Process Sheet

: BRACKET ASSEMBLY

D3155 REV C **Drawing Number** Project Number : N/A

NCR:		Wo	ORK OR	DER NON-CONFORMANCE	(NCR)			
		Description of NC		Corrective Action Section B	Verification	Approval Chief Eng	Approval QC Inspector	
DATE	STEP Section A				Sign & Date			Section C
0.105/24	3	- I part dimension . 130 is . 110 en one side "machined tapeted" - 15 part acceptable?	Source	Part acceptable See Empil	5-L 06/05/24	06.06.05	BOOM	12.06.05

DESIGN	DRAWN BY	DART AEROSF HAWKESBURY, ONTAF	
CHECKED	APPROVE	DRAWING NO.	REV. C SHEET 2 OF 2
DATE		TITLE	SCALE
04.10.06		BRACKET ASSEMBLY	1:1

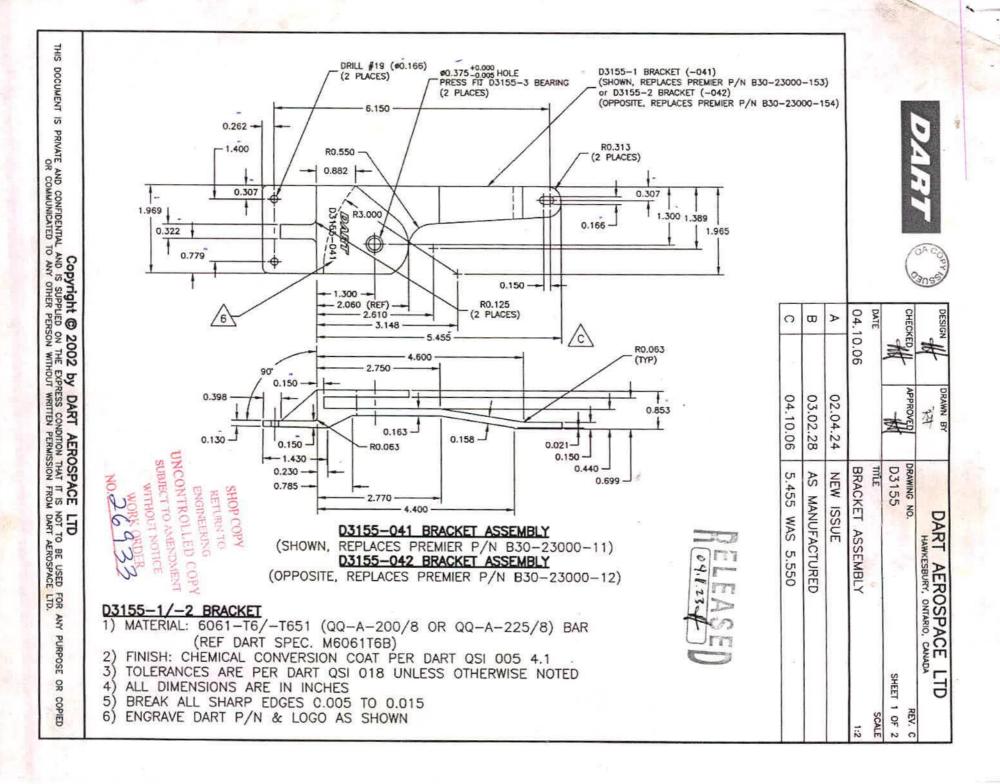
Good day. I have some parts off the haas that are under tol. If you look at dwg 3155-041/-042 the thickness of mat'l should be .130, and the taper I have comes down to .110 at the very tip of the mat'l. These holes are only for bolting on to the space doors to keep the lock and rod mechanism up higher. 1st : .110 ; 2nd : .110 ; 3rd : .114. Are these parts acceptable to you?

These parts are acceptable deviations.
